Addendum 02

DOCUMENT 00 91 00

PROJECT: Upper Scioto Valley Ambulance District
12231 State Route 235
Harrod, Ohio 45850

PROJECT #: 25023.00

SHEET NUMBER:
L1.1

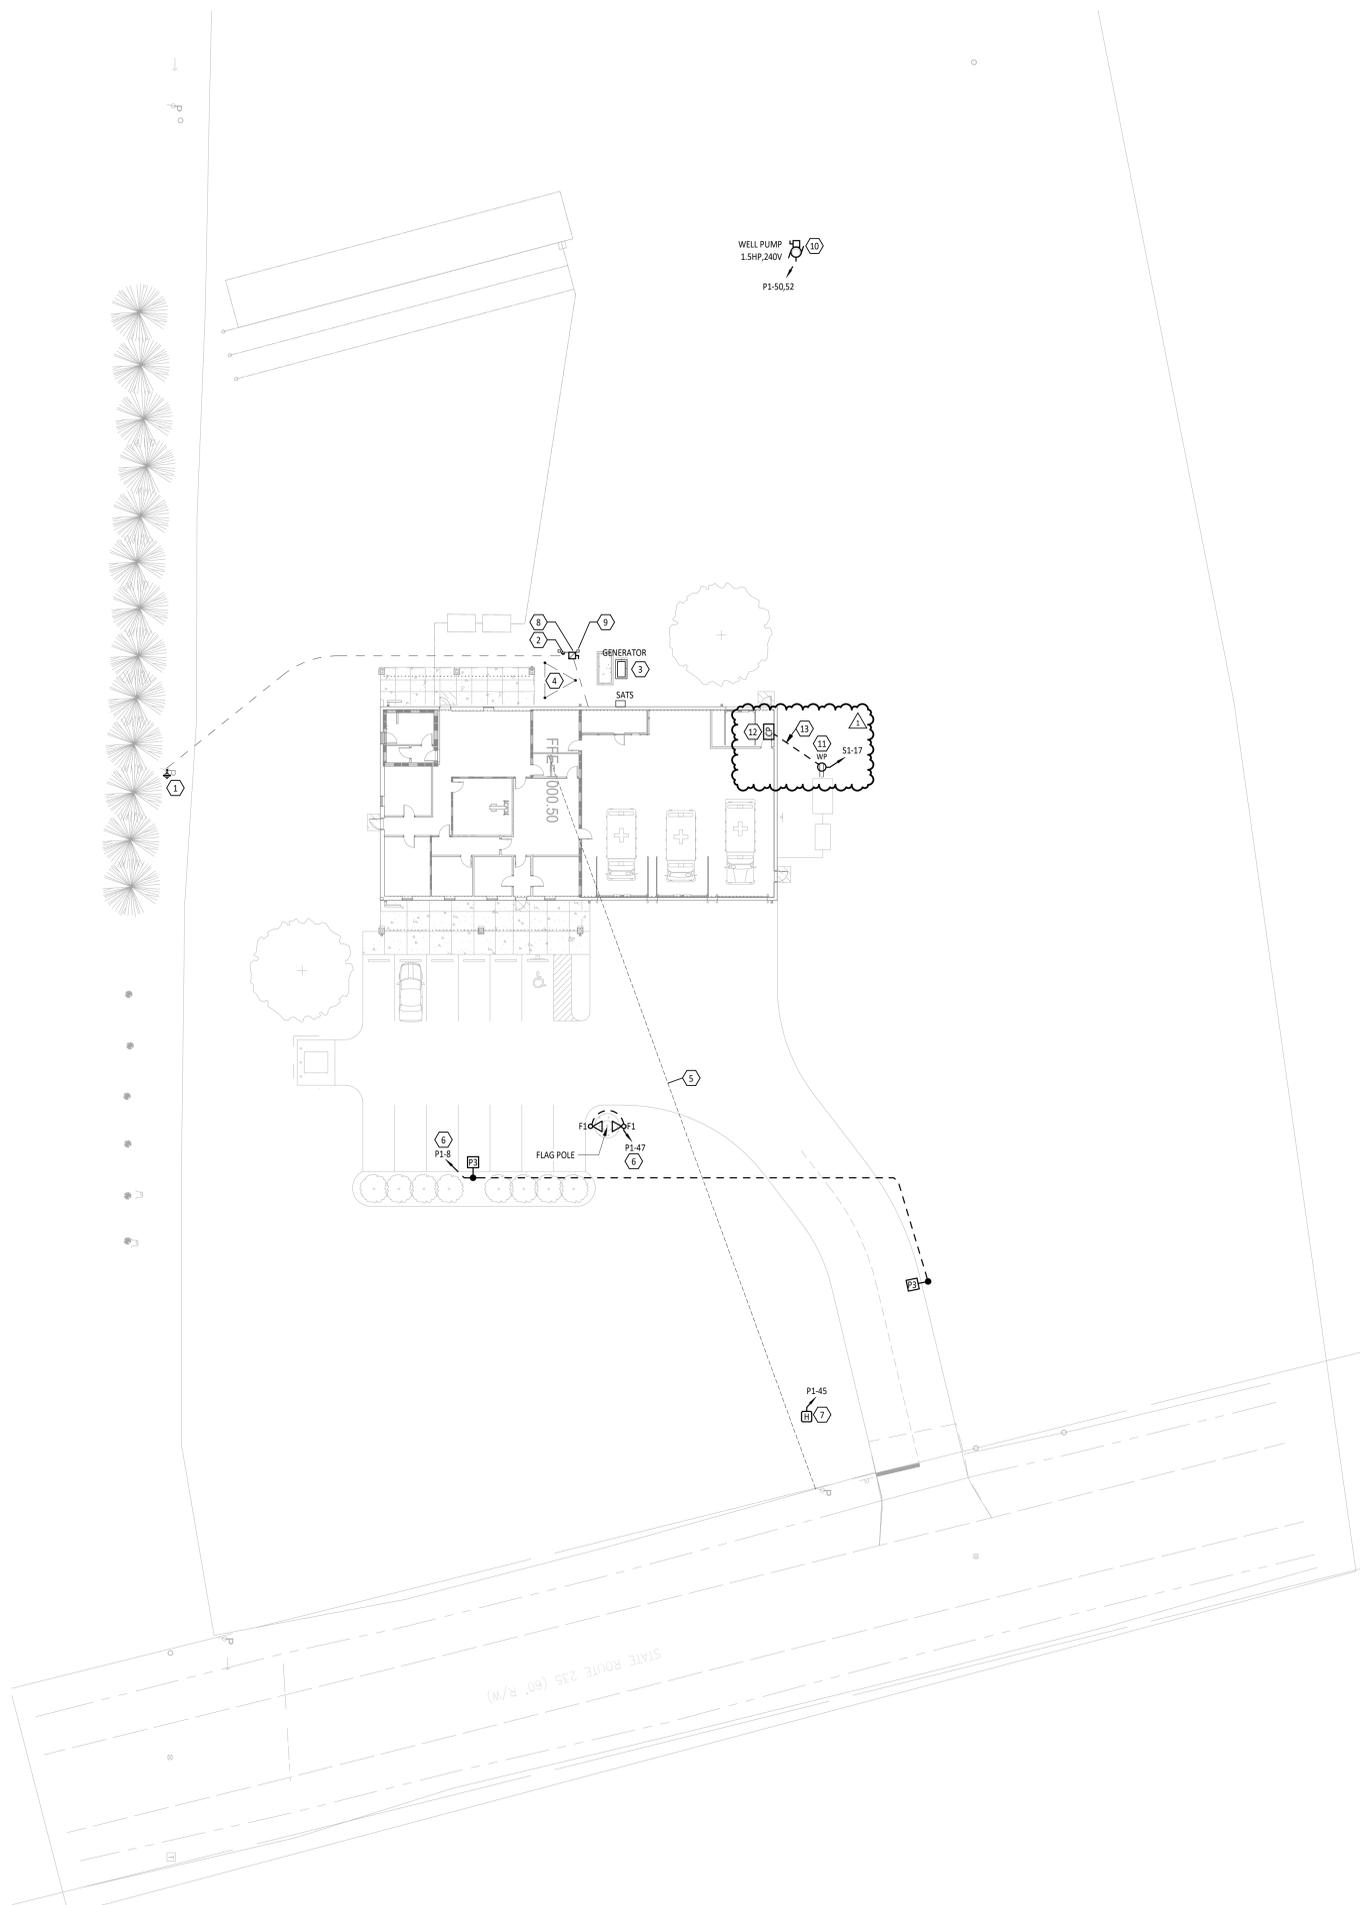
3. Drawing Sheet L1.1 Site Layout and Materials Plan: Marked Keynote S7 as Not Used
4. Drawing Sheet E2.1 Site Electrical Plan: As part of alternate #10: Add remote alarm panel for sump pump along with all associated conduit and wiring.

9. Is note S7 still relevant even though there is no asphalt?
 - a. **Response: Keynote S7 no longer applies. This keynote has been changed to “Not used” on sheet L1.1.**
